CITY OF PORTSMOUTH, NH

MADBURY WTP UPGRADE AND
BELLAMY RESERVOIR IMPROVEMENTS

RESPONSE TO BIDDERS QUESTIONS No. 3

AND
ADDENDUM No. 4

WTP SCADA BLOCK DIAGRAM

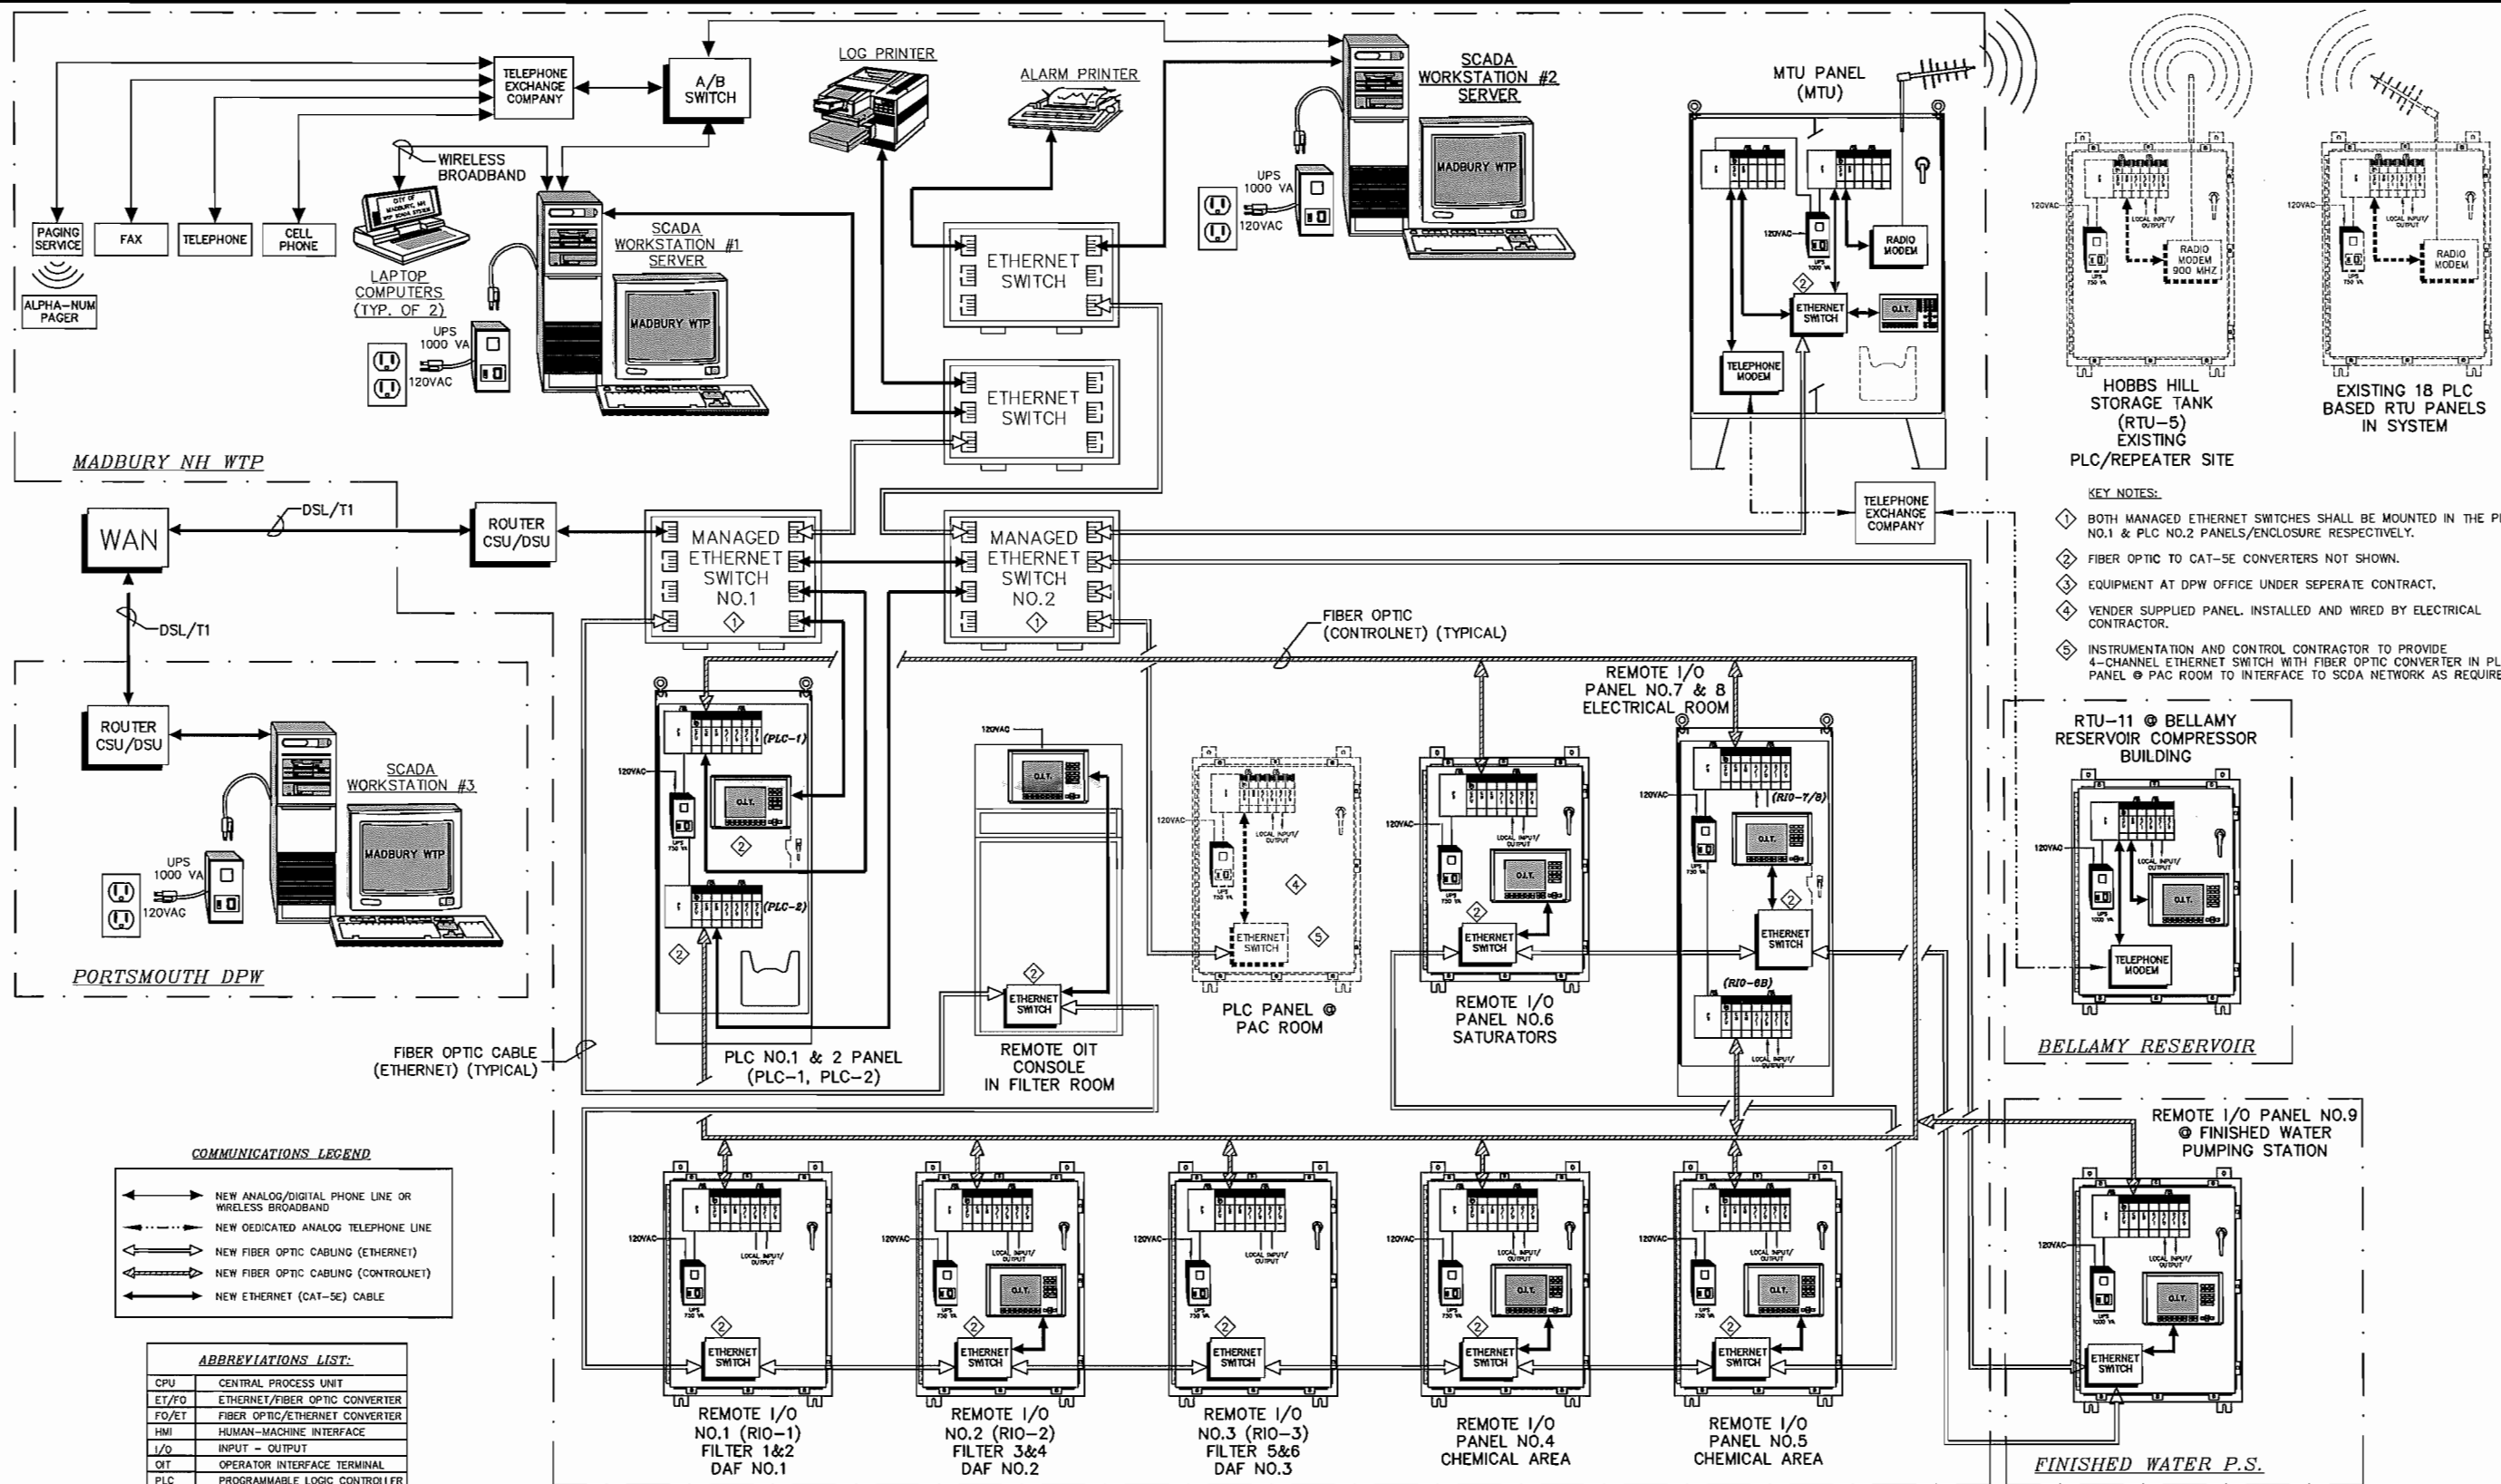
Item 4-9. Drawing I-2

- A. Delete Drawing I-2 in its entirety and replace with the attached Sketch I2-SK-01.
